PERKINS
+ WILL

Memo

Subject: **Task D. Stanford University Site and Bulk Control Revisions**

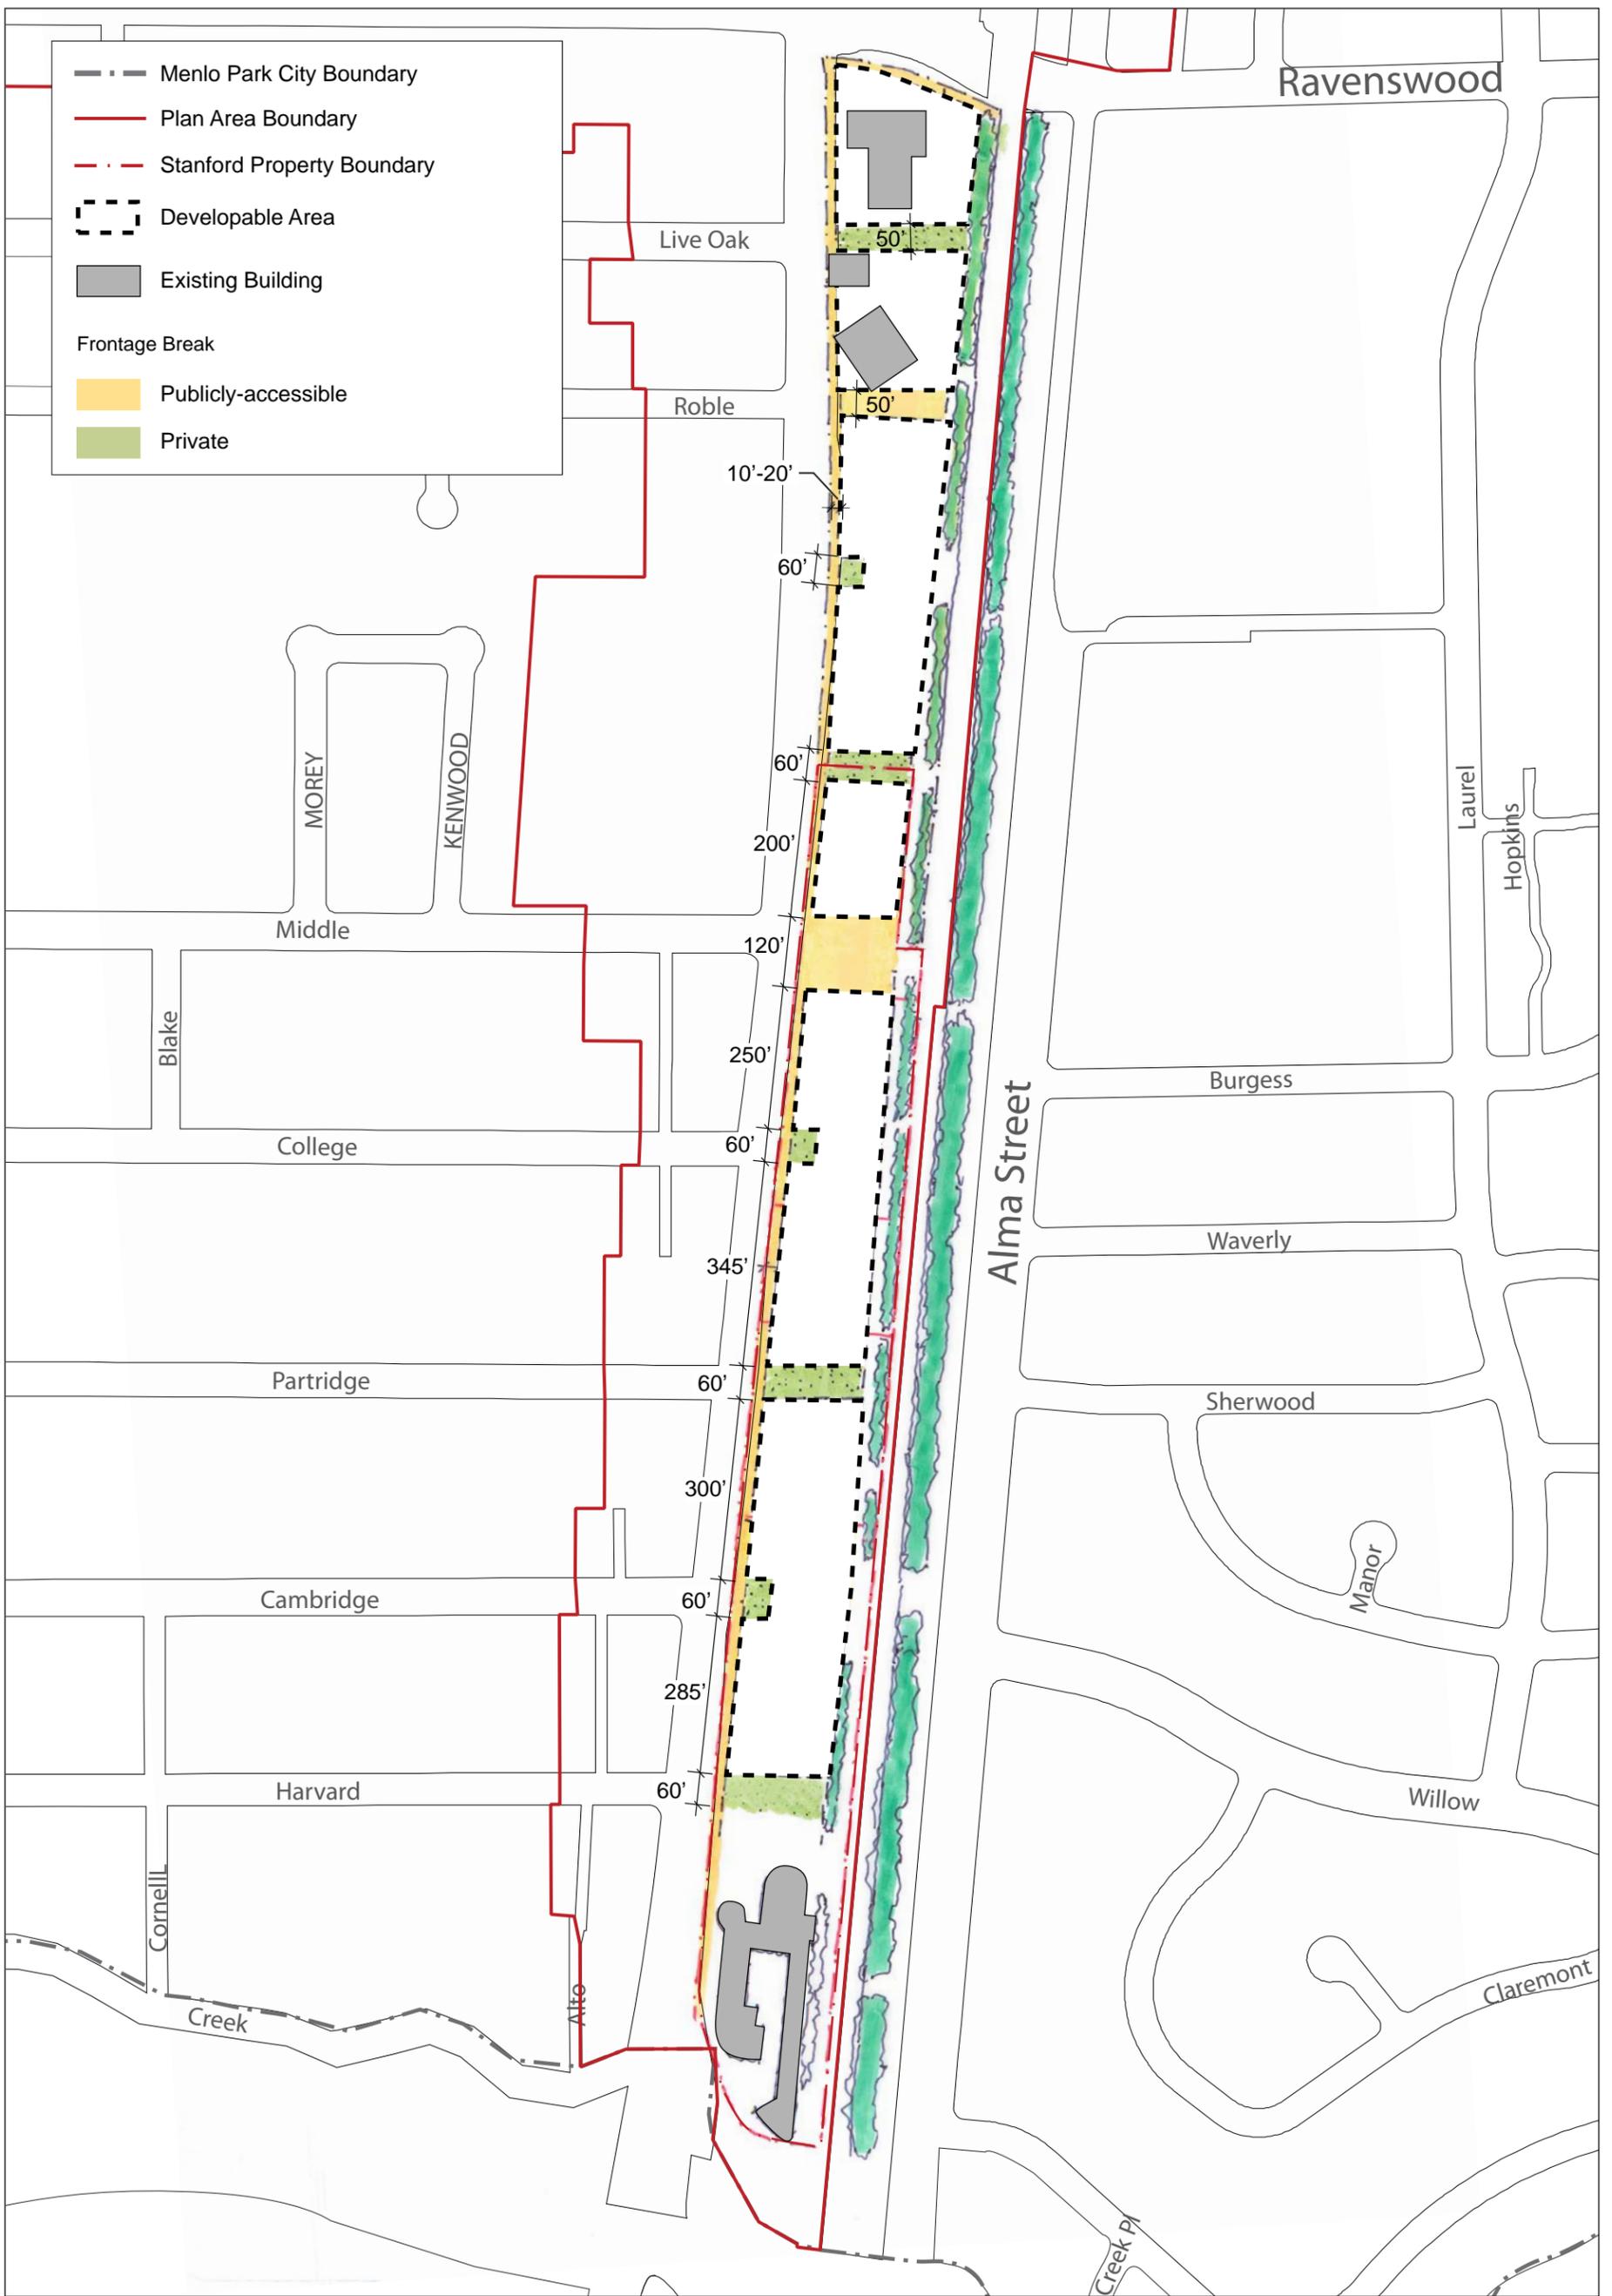
Site/Bulk Control	Draft Specific Plan	Stanford Request	Proposed Specific Plan Revisions
Building Breaks	4 Breaks Required, with 2 publicly accessible	Encourage Breaks; Require 1 Break at Middle	3 Breaks Required, with 1 publicly accessible at Middle
Middle Ave Break	120' minimum	60' minimum in vicinity of Middle	120' minimum; this would be the only publicly accessible break required, and it would allow for plaza and retail
Cambridge Ave Break	90' minimum	Articulate/recess building at Cambridge but no break	Articulate/recess building at Cambridge but no break
Additional Breaks South of Middle	2 required, with breaks located above a parking podium (vs. at-grade); Breaks to align with College and Partridge	Require no building breaks	Articulate/recess building at College but no break; Require building break at Partridge
Rear Setback	20' minimum	Require no rear setback, except what is required by the Fire District	Require no rear setback, except what is required by the Fire District

Open Space Requirement	40% minimum	20% minimum	30% minimum
Sustainability	LEED-ND for larger projects	No LEED-ND	LEED-ND for larger projects (with broader thresholds)

The major features of the proposed building breaks follow.

- The building breaks align with intersecting streets in the area, specifically Live Oak, Roble, Middle, College, Partridge, Cambridge and Harvard. (Note that the breaks north of Middle Avenue do not apply to Stanford lands but are retained as shown in the Specific Plan).

- The building breaks take the form of actual building separation or building recesses.
- To ensure viable building pads, building breaks in the form of building separation are required at Middle, Partridge and Harvard. These separations allow for building pads from 200 feet in length (for Stanford property north of Middle) to approximately 650 feet in length (Middle to Partridge and Partridge to Harvard).

- The building break at Middle is to be publicly accessible (discussed below). The other two breaks are open space to be used as Stanford deems fit.
 - The building breaks have an added value of allowing those travelling on Middle, Partridge and Harvard towards El Camino Real to have a view of open space rather than buildings, thereby reducing the visibility of larger development from these neighborhoods.

- The building breaks at College and Cambridge take the form of building recesses, acknowledging the intersecting streets. The recesses can serve as courtyards/entrances for the buildings, including vehicular access as appropriate.

- With the exception of Middle (discussed below), the building breaks (both building separation and recesses) are 60 feet wide, generally consistent with the right-of-way dimensions of the intersecting streets.
